UNITED STATES PATENT AND TRADEMARK OFFICE  
**CERTIFICATE OF CORRECTION**

PATENT NO. : 6,906,961 B2  
APPLICATION NO. : 10/602991  
DATED : June 14, 2005  
INVENTOR(S) : Eggleston et al.

Fig. 6B

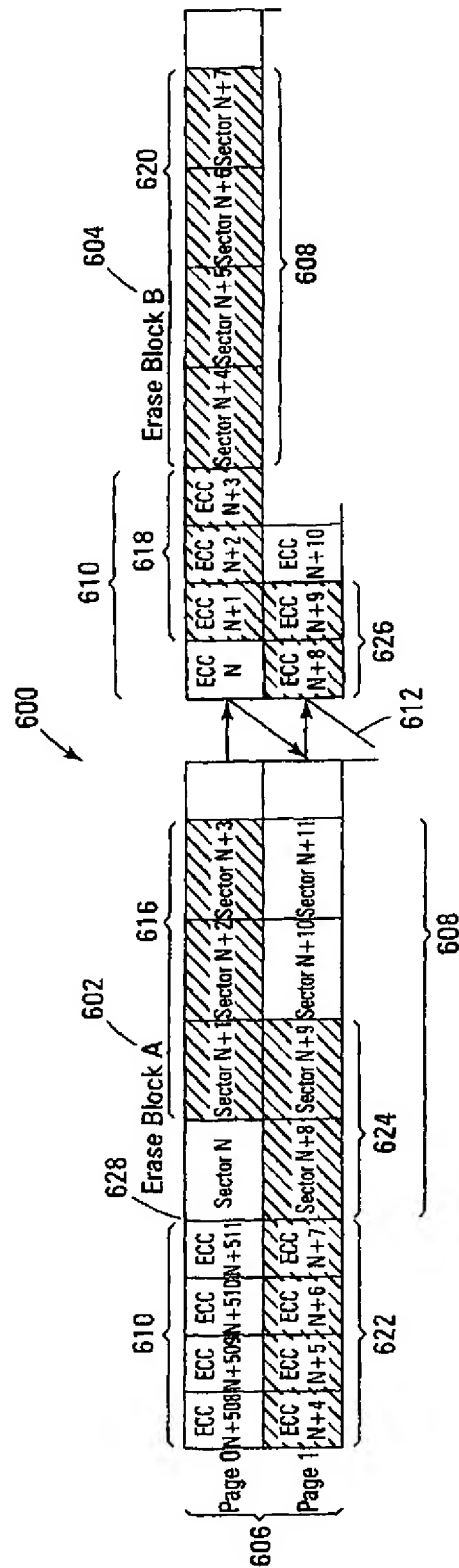
At sheet 9 of 12, delete Figure 6B and replace with attached Replacement Figure 6B.
